Memo

To: Matthew Burns
From: Buju Can Cetin, Conservation Officer

Application Number: PL/24/0846

Address: Napier Court Napier Road Reading

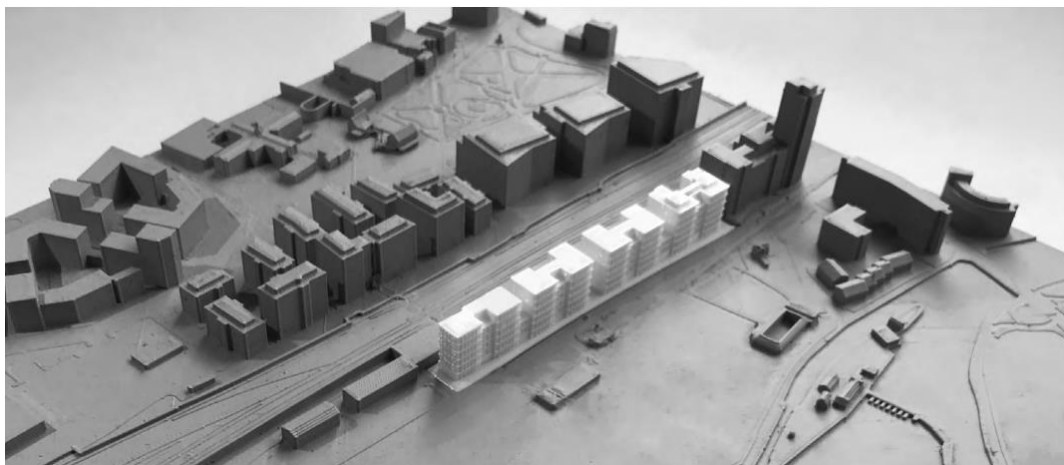
In principle, I would support the redevelopment of the application site for residential use. However, given its close physical relationship with the setting of Thames Lido – Kings Meadow – and the heritage asset group to the south of Forbury Road, I would like to raise some concerns about the scale, massing and built form of the proposed blocks, and I would like to make some suggestions for revisions.
